Adamstown Station District Centre, Co Dublin
Masterplan - Phase III - Blocks A, C & D

DESIGN STATEMENT Blocks A, C & D
REQUEST FOR FURTHER INFORMATION | SEPTEMBER 2022

Decision Order Number: 0723	Date of Decision: 08-Jun-2022
Register Reference: SDZ22A/0005	Registration Date: 14-Apr-2022

Block D North

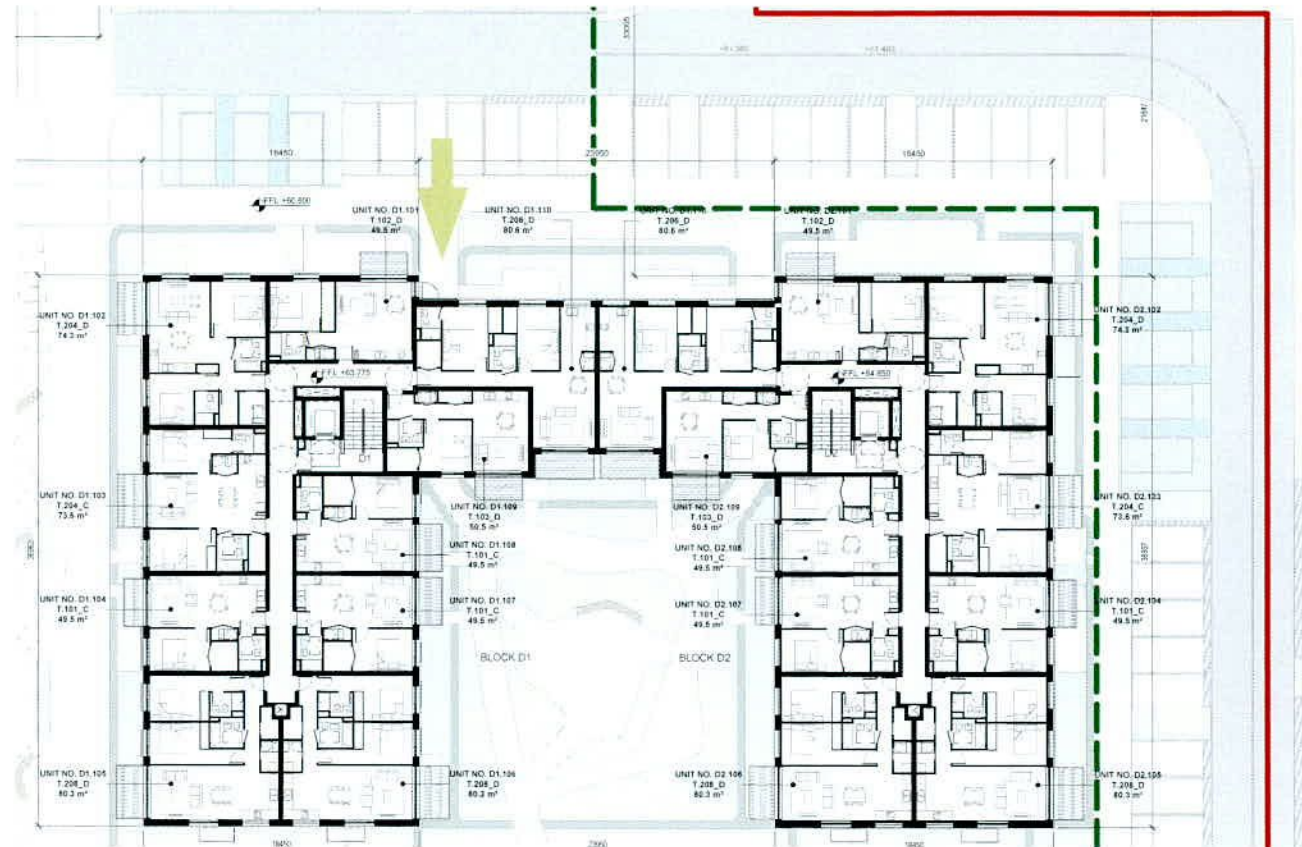
(a) The following apartments are north facing and single aspect, however, the Housing Quality Assessment states that they are dual aspect: D1.001 (T.102_D) D2.002 (T.102_D) These units front onto Great Western Way and it is not apparent that they overlook any significant amenity areas directly. The applicant is, therefore, requested to submit a separate schedule and plan indicating all single aspect north facing apartment detailing compliance with Paragraph 3.18 of the Apartment Guidelines. Any single aspect north facing apartments that do not meet the requirements of the Apartment Guidelines should be omitted. Any resultant change in the percentage of overall dual aspect apartments should also be set out.

Design and layout changes to the Core D1 & D2 and to the entrance hall facing Great Western Way updated to accommodate new apartment type T.301_D at Ground Floor and revised apartment type T.102_D as dual aspect unit on the Upper Floors.

Block D South

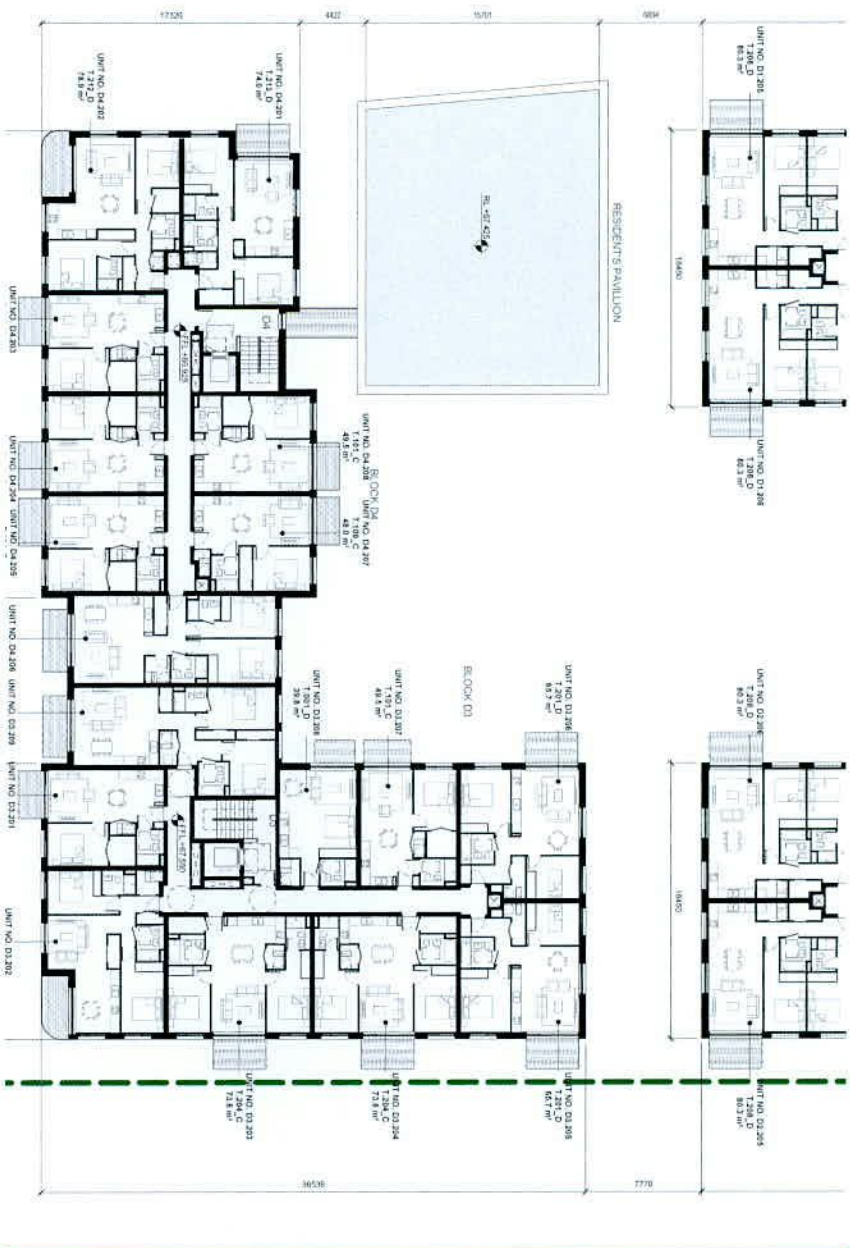
(b) In general, a good degree of separation is maintained. The exception to this is Blocks D2 and D3, where the separation distance between opposing windows is 7.77m. The Planning Authority is concerned that the living spaces are provided at the closest points, therefore increasing the risk of overlooking. Given the proximity of the apartment in D2 and D3, it would be preferable for the living spaces to be reorientated so bedrooms / bathrooms were opposing rather than living rooms. The applicant is requested to provide a rationale for the proposal or consider revised plans indicating the reorganisation as set out above.

Design and layout changes to apartment type T.202_D on Ground Floor and T.201_D on the Upper Floors to overcome privacy issues between Blocks D2 & D3. Apartment type T.202_D living spaces reorientated to minimize overlooking concern between Blocks D2 & D3

BLOCK D COURTYARD ELEVATION SOUTH - RFI PROPOSAL

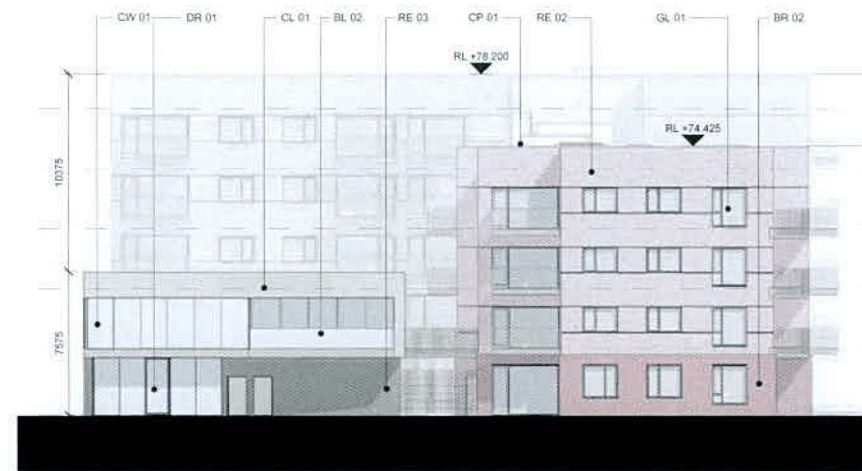
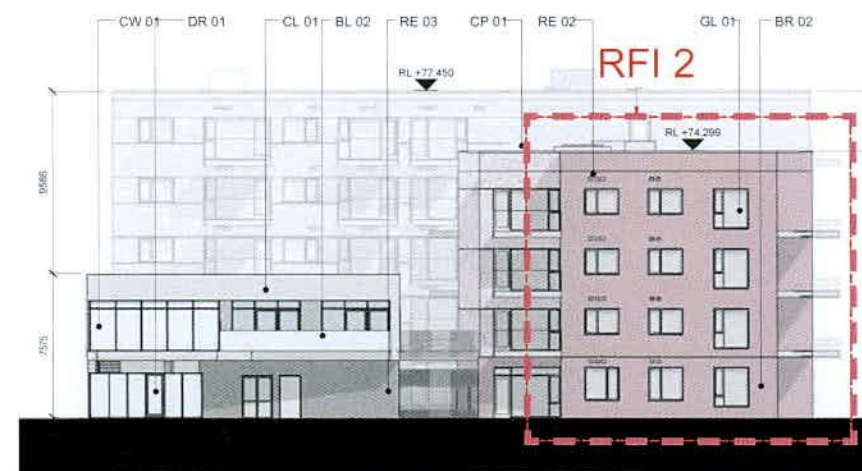
The materials and finishes proposed for Blocks A, C and D are considered generally acceptable. However, it is noted that render is provided along Station Road, and it is considered that, given the prominence of this location, brick should be provided. The applicant is requested to provide details of revised materials along Station Road frontages.

Design revised to replace Block D render facade material with brick along Station Road. Brick introduced to the facade on Block D upper floor levels.

RFI 2
 BLOCK D SOUTH - CHANGES TO FACADE MATERIAL TO BRICK ON THE UPPER FLOOR LEVELS

BLOCK D GROUND FLOOR PLAN - RFI PROPOSAL

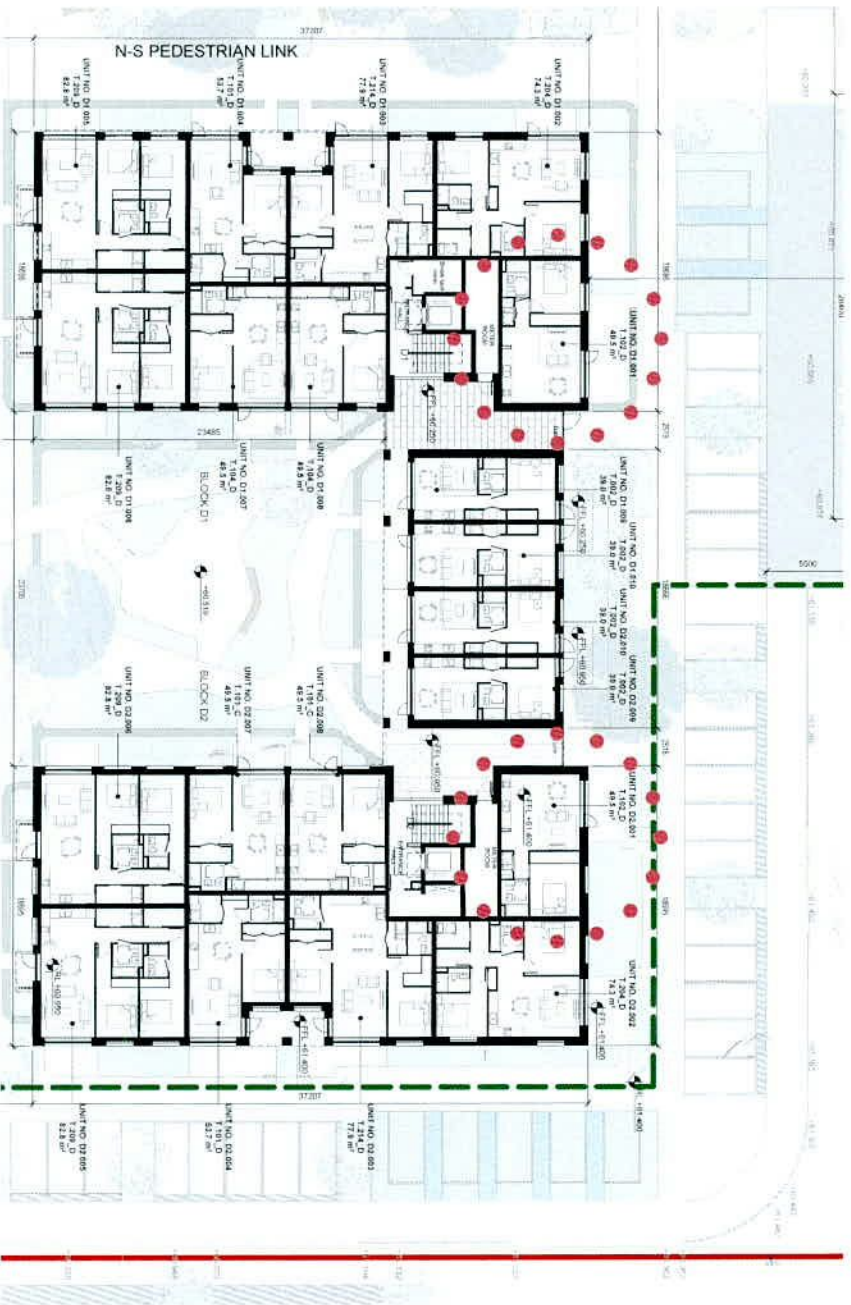
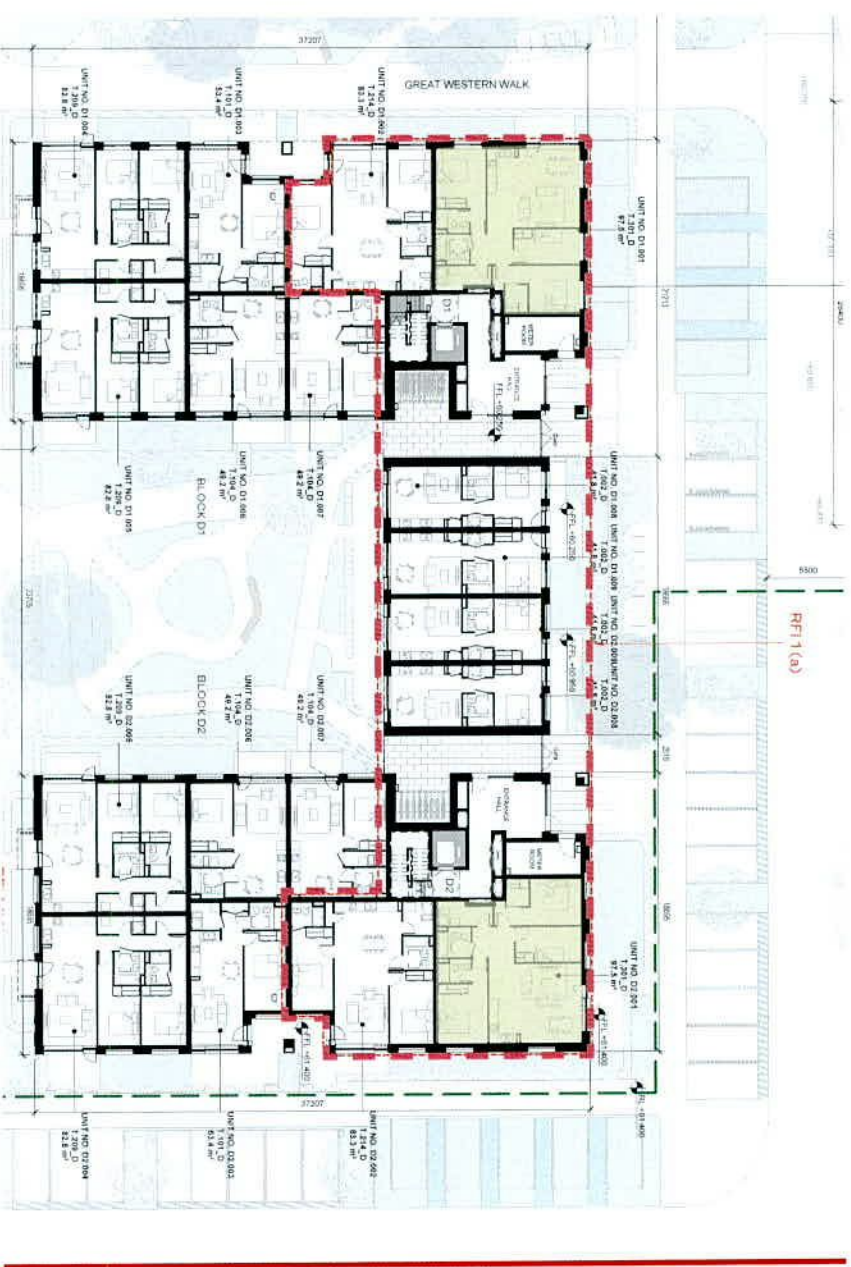
NOTE: GROUND FLOOR LEVEL SHOWED A WINDOW TO THESE UNITS BUT IT WASN'T EVIDENT IN THE PLANNING DRAWINGS

THE PREVIOUS TWO UNITS, T.102_D AT GROUND FLOOR HAVE BEEN OMITTED. THE PREVIOUS UNIT TYPE OF T.204_D HAS BEEN REVISED TO CREATE A NEW UNIT TYPE OF T.301_D (HIGHLIGHTED IN YELLOW) FOLLOWING THE ENTRANCE CORE DESIGN CHANGES, UNIT TYPE T.214_D FOOTPRINT AMENDED AS A RESULT THE FACADE HAS BEEN SETBACK BY 2.6M TO ALLOW FOR GREATER WINDOW DEPTH ON THE UPPER FLOORS. PREVIOUS DEPTH OF SET BACK WAS 1.6M
